**GEOTECHNICAL INVESTIGATION AND GEOLOGIC HAZARDS ASSESSMENT
PROPOSED BATTLE CREEK AND LANDAU
RESIDENTIAL SUBDIVISION DEVELOPMENT SITE
TAX LOT NO. 900
5826 BATTLE CREEK ROAD SE
SALEM (MARION COUNTY), OREGON**

STATE ST HOMES INC		THE RESERVE AT BATTLECREEK		DRAWING ST-1		JOB NUMBER 3063.0000.0	
A STREET PLAN & PROFILE 20+00-23+50		WESTECH ENGINEERING, INC. CONSULTING ENGINEERS AND PLANNERS		DATE: 09/2020		NO. 1	
3841 Fairview Industrial Dr. S.E., Suite 100, Salem, OR 97302 Phone: (503) 585-2474 Fax: (503) 585-3986 E-mail: westech@westech-eng.com		VERIFICATION SCALE BAR IS ONE INCH ON ORIGINAL DRAWING IF NOT ONE INCH ON ORIGINAL DRAWING, SCALES ACCORDINGLY		DSN. JW DRN. AK CKD. JW		DESCRIPTION REVISIONS	
						BY

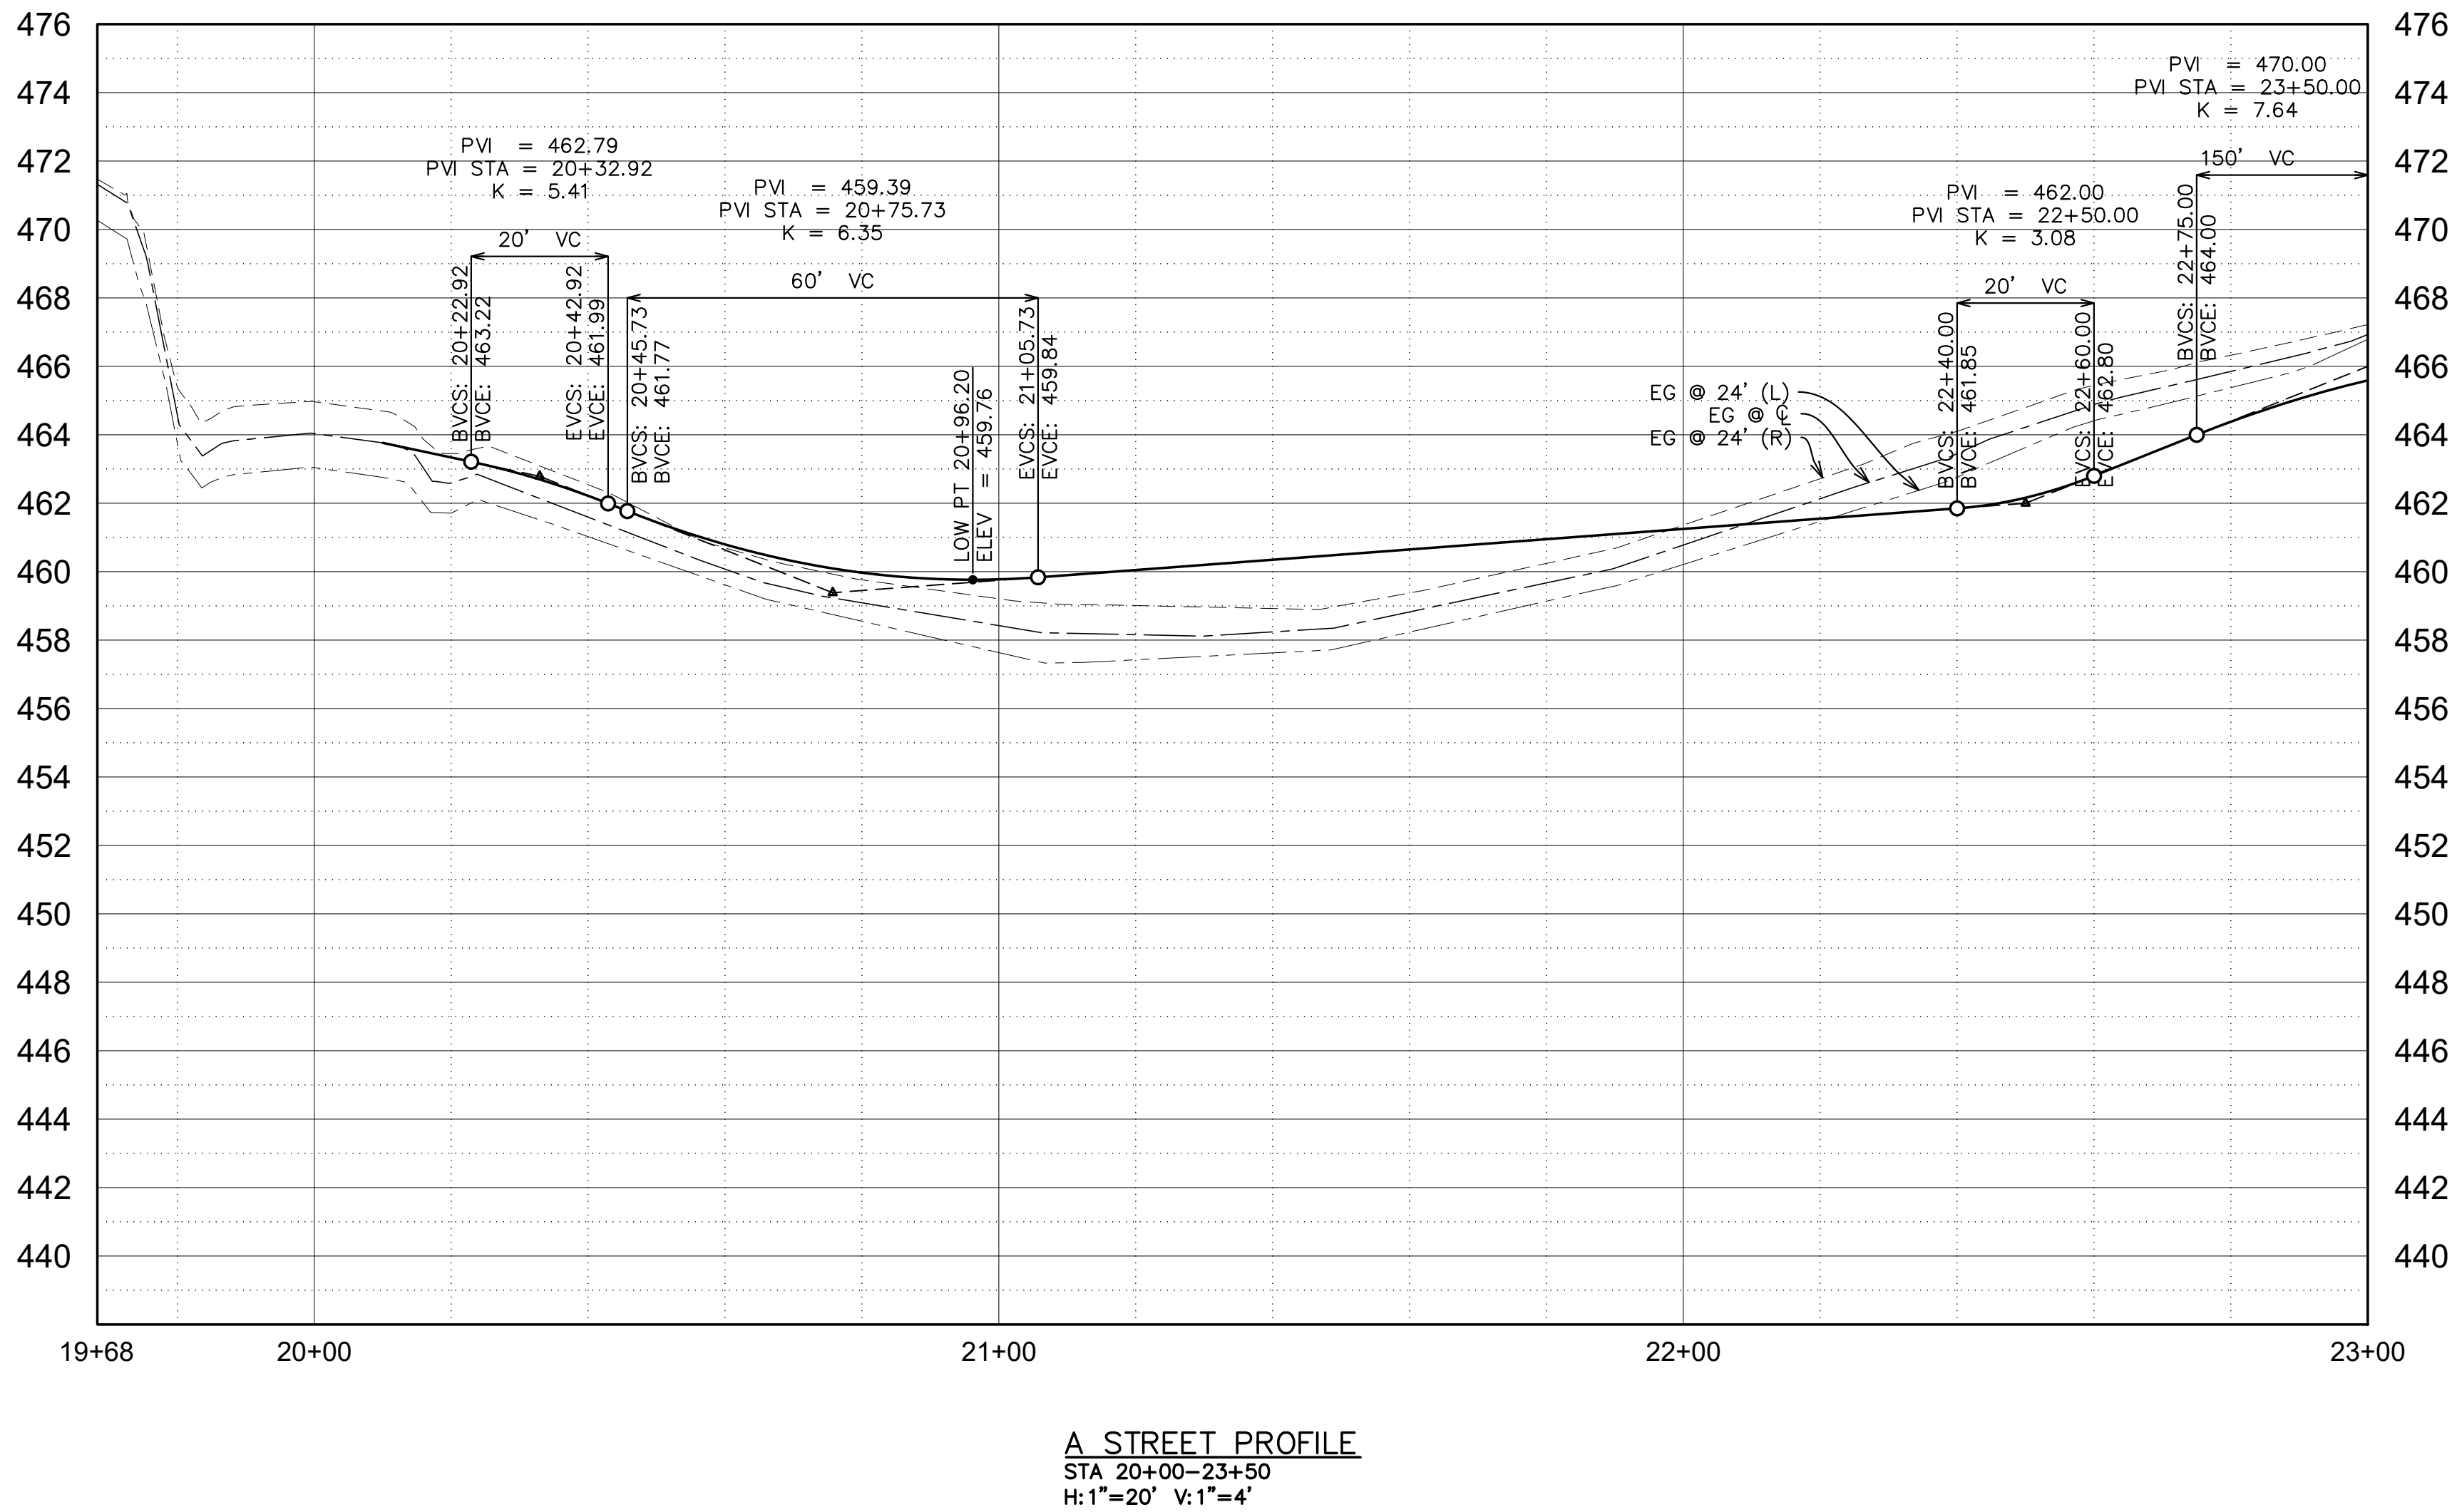
Street grades need to be indicated on street profile. Local street grade cannot exceed 12 percent.

Subject: Group
Page Label: [1] G-3 OA Subdivision Plan
Lock: Unlocked
Status:
Checkmark: Unchecked
Author: jrscott
Date: 12/16/2020 3:20:53 PM
Color: ■
Depth:

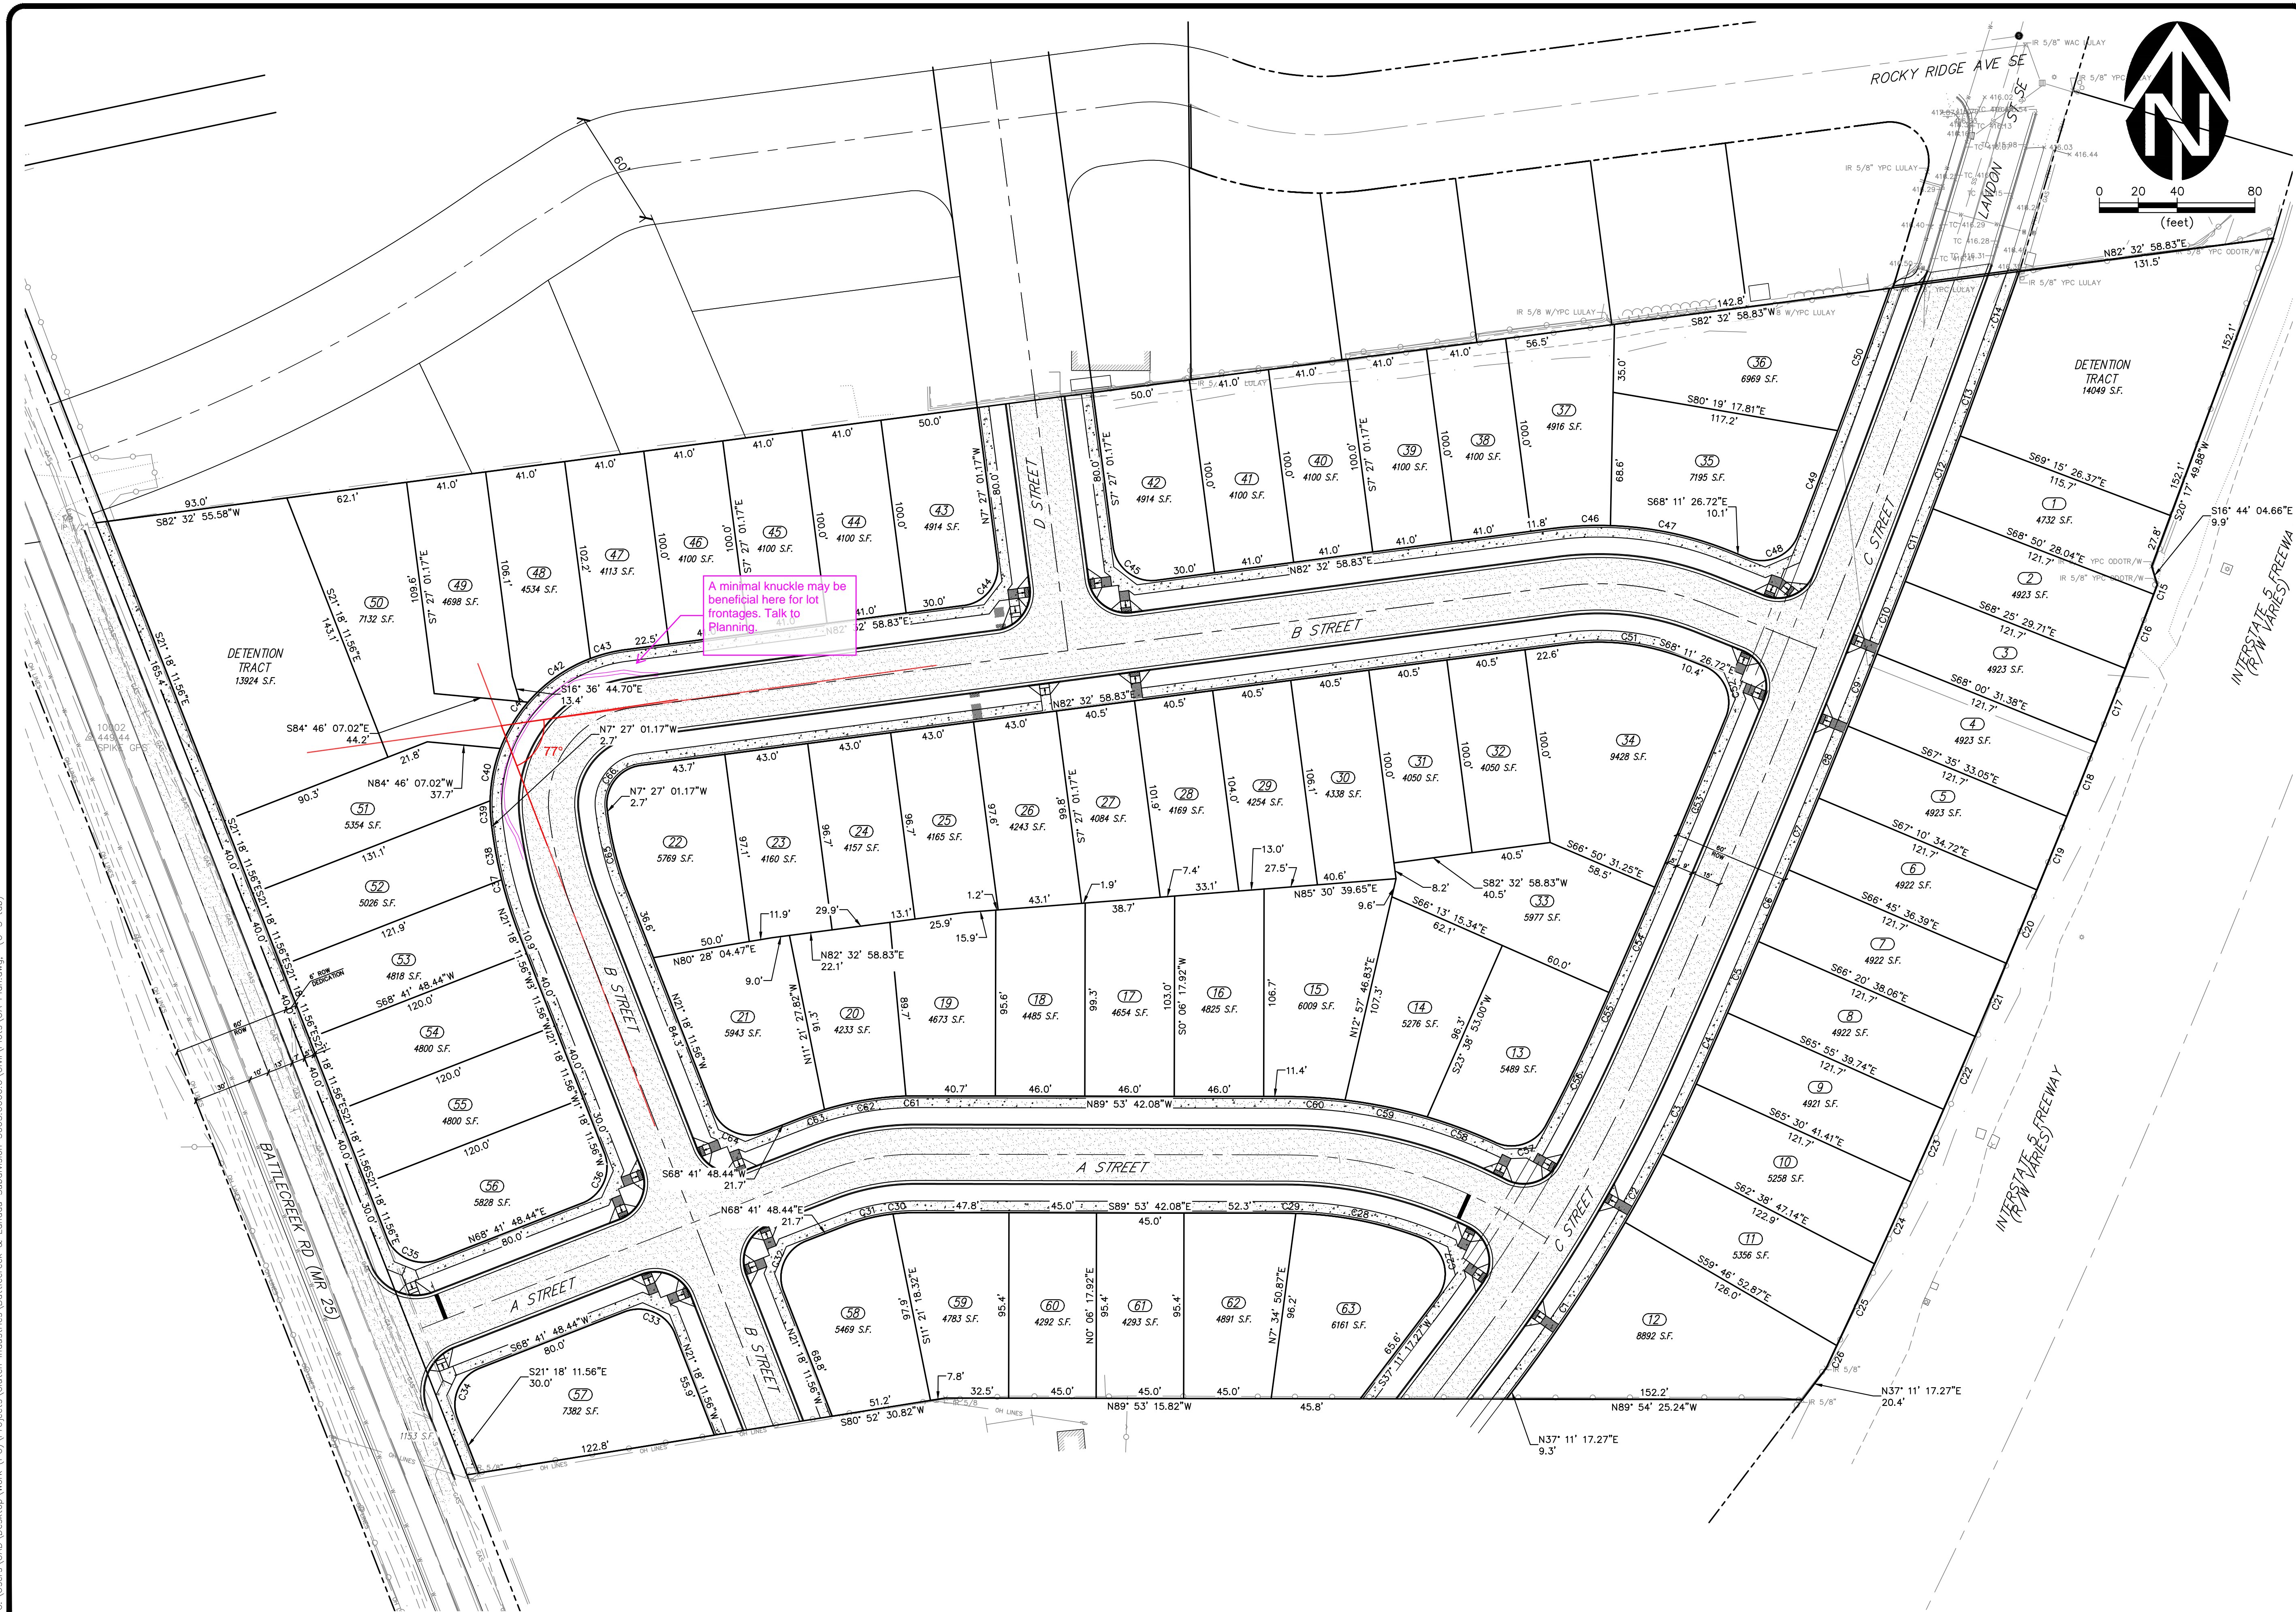
A minimal knuckle may be beneficial here for lot frontages. Talk to Planning.
